# PlanGrid Task Report - Aug 30, 2024

TAB Punch List

**L05622\_Marion (IL) FSU**

## #121 [EXHA 001][NEW]Critical- Grease duct access doors.

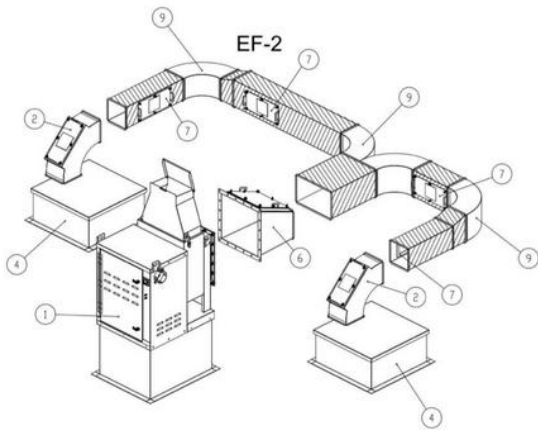
Access doors are missing on  
EF-2 grease duct.

## #48 [CNTL 017][NEW] CRITICAL: AC-1 thru 3 Thermostat Terminations Incorrect

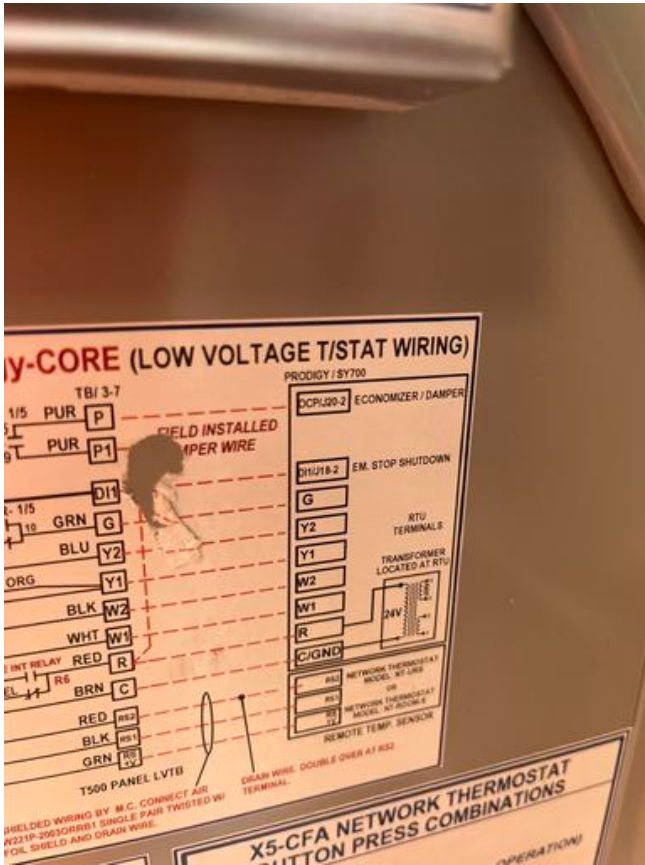
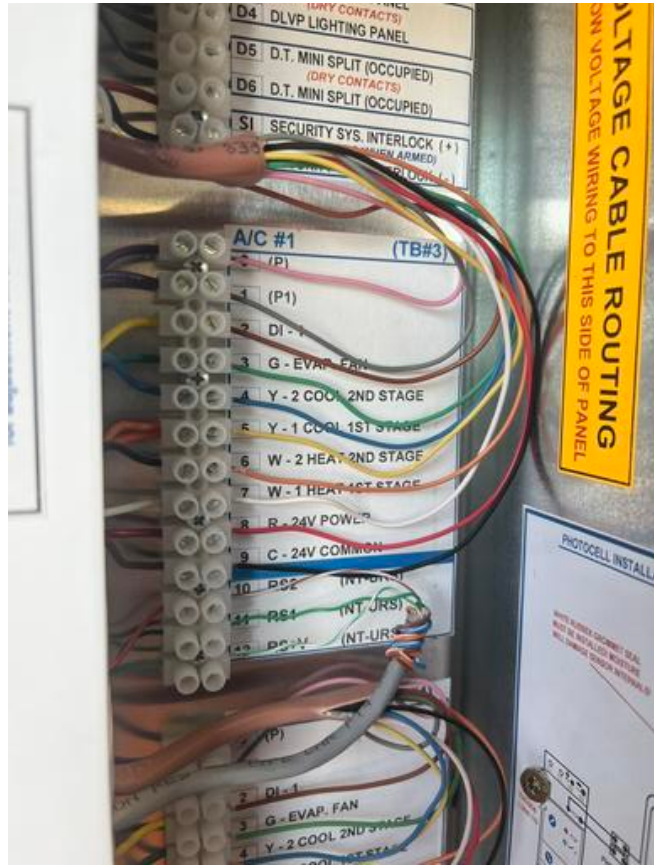
Thermostat wiring does not include correct wiring for occupancy on AC-1,2,3. Jumper from P1 to R is not installed in SEC. P should terminate at J20-2 on main Symbio board. Currently P1 and P terminate at J8-1/2 on CCM. Units always occupied. Alternatively P1 can terminate at J20-1 for 24vac. MSET and SEC wiring diagrams conflict.

Wiring corrected, occupancy operating correctly

## #47 [CNTL 017] [NEW]CRITICAL: AC-4 Thermostat terminations incorrect

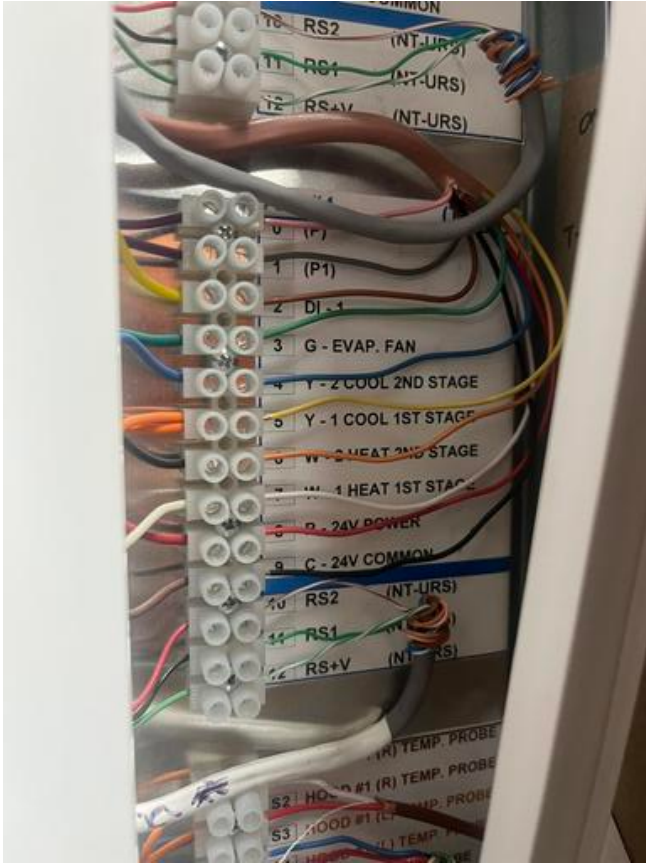
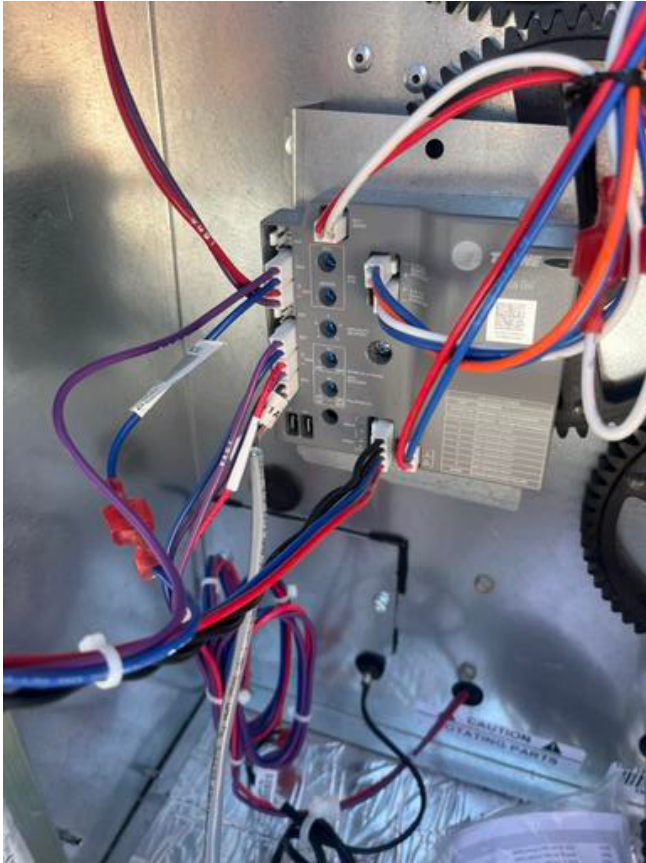
Thermostat wiring does not include correct wiring for occupancy. Nothing landed on P1/P at economizer module. P1 from SEC is wire nuted at unit. P appears wired to G. Unit always occupied.

## #46 [CNTL 514][NEW] SEC ice cube relay wiring

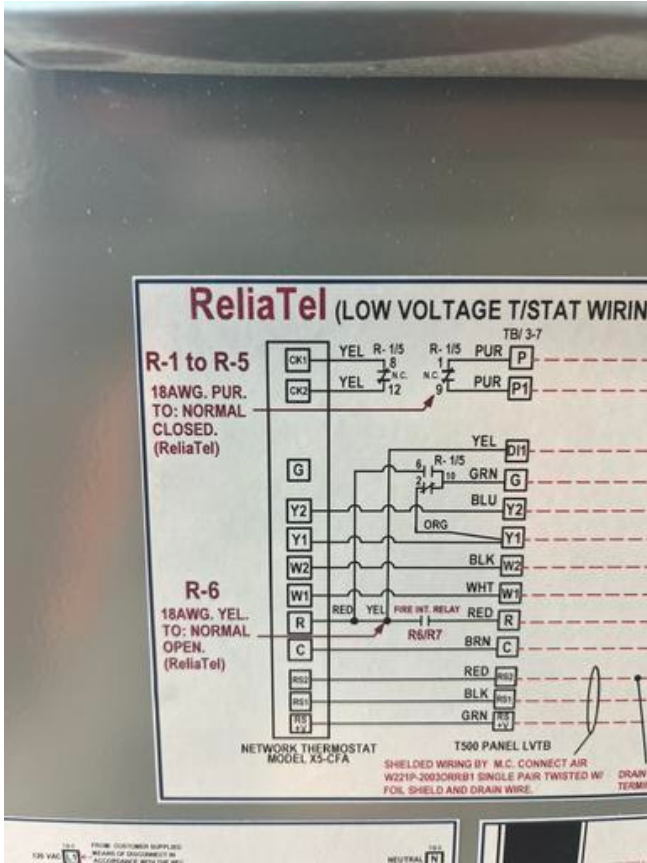
R-1, R-2, R-3 relay improperly wired for occupancy on Symbio units. 18AWG purple should be on normally closed. Purple on R-1,2,3 needs to be moved to front row for occupancy to be properly controlled. See also: Issue 47 AC-4 thermostat terminations.

Corrected by mc

## #40 [DUCT 017][NEW] CRITICAL-Duct Not Installed Per Plans

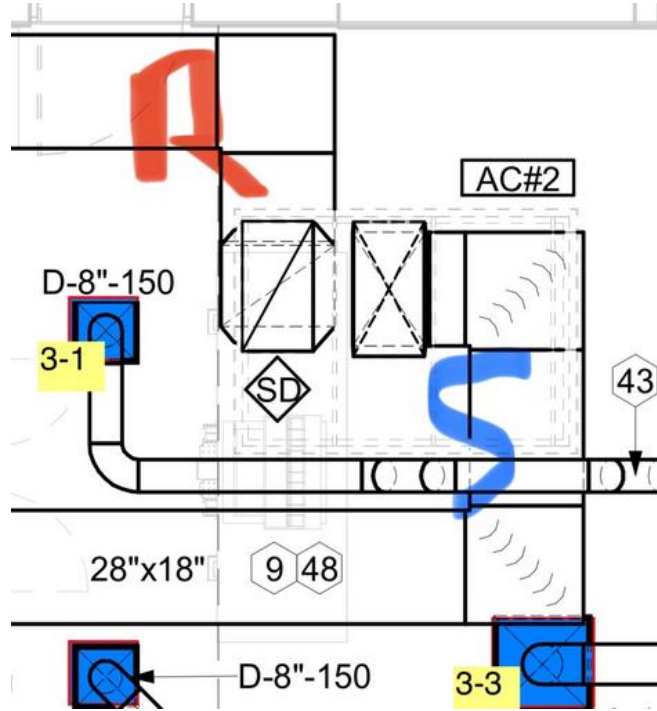
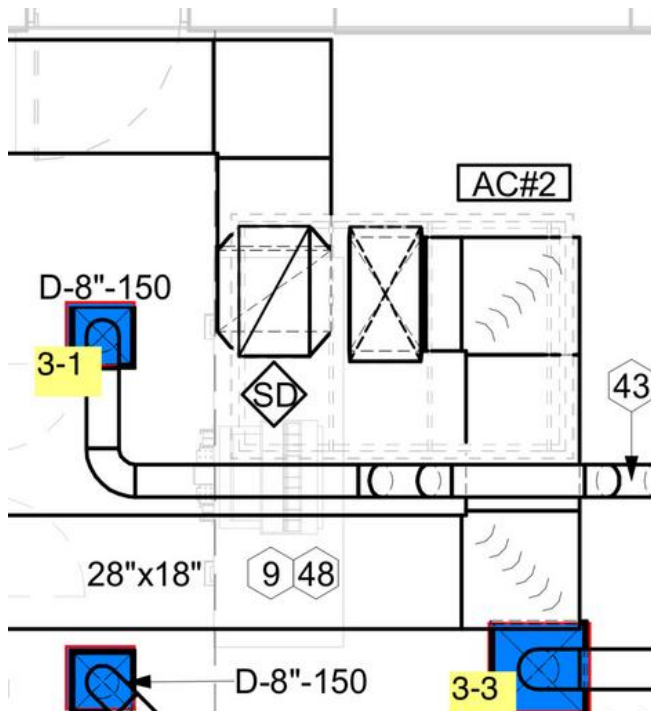
Duct is constructed in a way that impedes airflow. Unit was rotated opposite from plans on roof because EF-1 proximity to fresh air intake. Supply and Return locations swapped. Additional 90 added to return. Return static pressure measured at -1.00" WC. Unit achieving design airflow however has slight vibration, economizer dampers have rattle, and return dampers are making noise in drive-thru area. SEEK APPROVAL.

## #37 [HOOD 999][NEW] (MISC) Caulking on HD-3 Access Panel

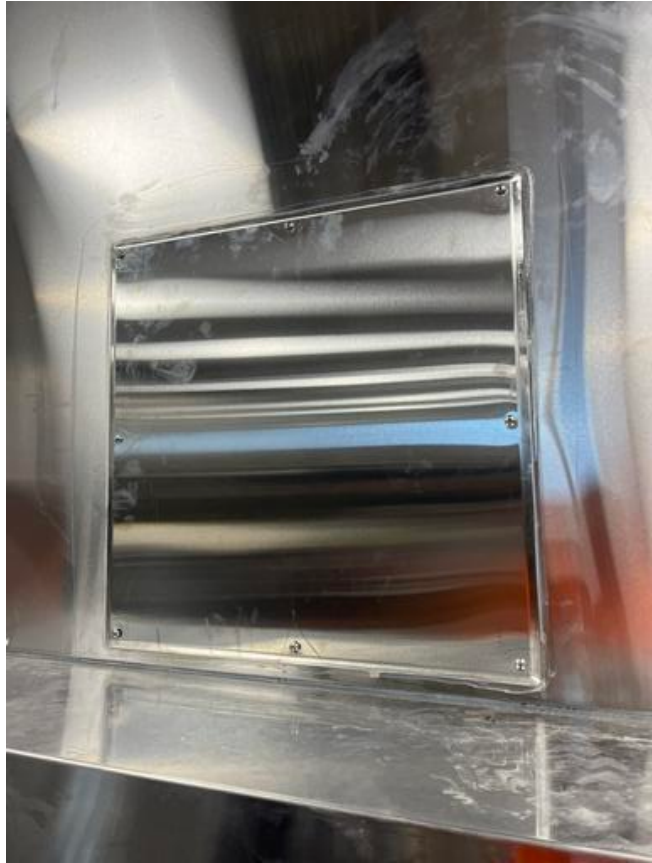
Appears caulk was applied to access door on HD-3. Recommend residue is removed.

## #36 [CNTL 017][NEW] CRITICAL-Thermostat Terminations Incorrect

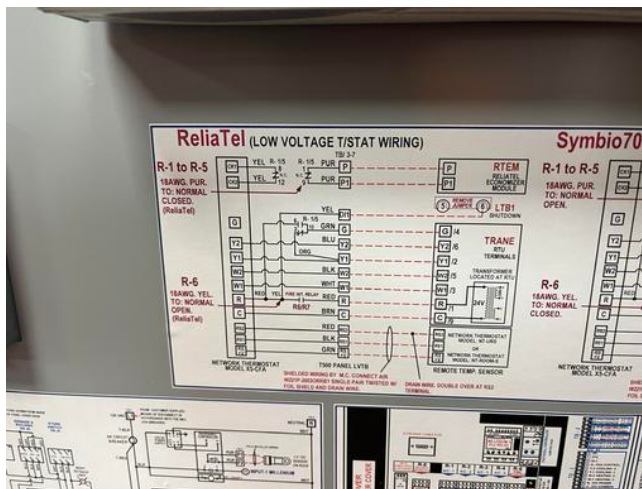
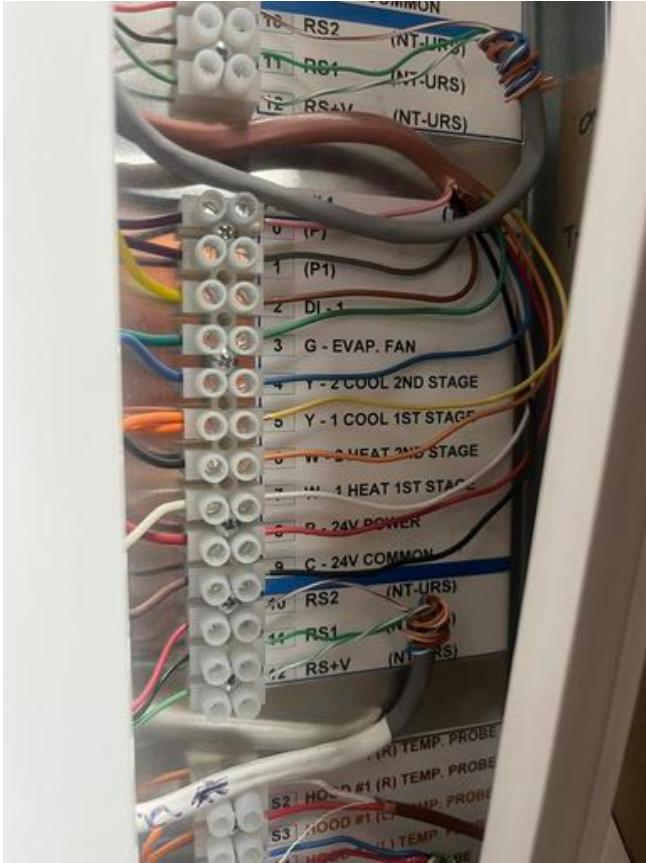
AC-4 thermostat wiring not terminated correctly. Per plans, DI-1 to terminate at LTB 6-estop, and jumper between 5-6 to be removed. DI-1 currently wire nutted in unit.

Corrected by controls/tab. Fire interlock on ac-4 had to be swapped

## #35 [CNTL 999][NEW] AC-4 Temp Sensors Not Installed

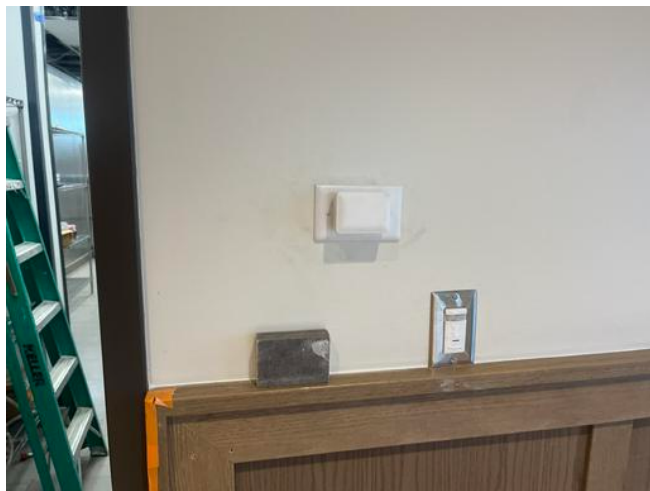
Avg. sensors for AC-4 are not installed. Only temp sensor 1 is installed.

Additional sensors installed and wired by controls contractor.
